PART 21 REPORT - ESI REFURBISHED EMERGENCY DIESEL GENERATOR CYLINDER HEADS MAY HAVE VALVE KEEPER SEALS MISSING

Report No. 10CFR21-0108

COMPONENT: KSV Cylinder Head with Missing Keeper Seals
Head Part Numbers 10-KSV-11-3-RR, 12-KSV-11-3-RR, and 13-KSV-11-6-RR

SYSTEM: Emergency Diesel Generator

Figure 1: Showing Location of Keeper Seals

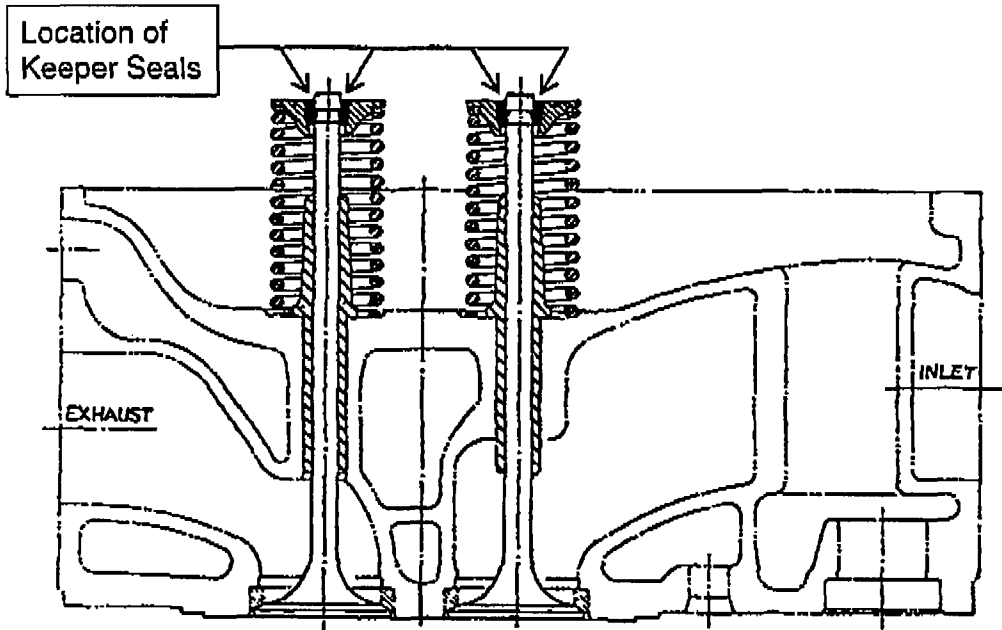
During the failure analysis investigation performed at the current Cameron facility in Casper, WY, it was noted that the intake and exhaust valve keeper seals, P/N W30C-1#1, were not installed. The purpose of the keeper seals is to deflect lube oil from draining into the cylinder head, and possibly the combustion chamber, during standby conditions. The source of this lube oil is the intake and exhaust rocker arms that are pressurized with heated lube oil during standby conditions to maintain the engine's fast start capability. The quantity of oil that travels through the rocker arms to the valve keeper area is dependent upon the component clearances within the rocker arm components. The absence of the valve keeper seals could allow a small amount of this lube oil to drain past the keepers, down the valve stem, through the valve guides and into the intake and exhaust ports of the cylinder head. In this particular case, the intake or exhaust valves were sufficiently open to allow oil to enter the cylinder (which is dependent upon the engine's position when it stops rotating following a shutdown). One or more cylinders on an engine will have open valves at any given position of the crankshaft, though not all cylinders are affected at the same time.

The seals are made of an elastomeric material in the form of a rectangular block and they are replaced during a rebuild as standard practice. Each cylinder head has eight seals (with two required for each valve and there are four valves per head). The seals are installed between the keeper halves on opposite sides of the valve stem. See figure and photo on the following page for a visual representation of the seal location.

Absence of the keeper seals could allow lube oil to leak through the valve guides, into the cylinder head, and into the combustion chamber during standby conditions. Excess oil in the combustion chamber could prevent the piston from stroking its full length during a compression or exhaust stroke causing hydraulic lock. This could cause catastrophic damage to the engine's power assembly components and render the engine inoperable.

Inspect the valve keepers for presence of the keeper seals. If seals are installed, no further action is required. If seals are not installed, it is recommended that a borescope inspection be performed to ensure no engine lube oil is in the combustion chamber. This inspection could be performed through the fuel injector bore or the Kiene valve passage (if equipment will allow).

If oil is present, then immediate action is required to remove the oil and rework or replace the cylinder head. Reworking the head can be performed on-engine as follows: With the Kiene valve open, the engine should be barred over until the piston is at top dead center. By doing this the oil will be pushed out of the Kiene valve. Lock the barring device to maintain the piston at TDC and connect a pressure test set to the Kiene valve. This pressure will be used to hold the valves against the fire deck of the cylinder head. An applied pressure of 50 psig should be used; however higher pressures may be utilized as required to maintain the valve against the fire deck. Remove the rocker arms to access the top of the valves. Using a valve spring compressor (such as P/N LS-44-AA#7), compress the spring retainer enough to loosen the keepers and insert the keeper seals. Replacement keeper seals are available from ESI as dedicated components. Relieve the spring compressor and ensure the keeper seals are fully inserted between keepers and flush with the top of the keepers. Repeat for the remaining valves.
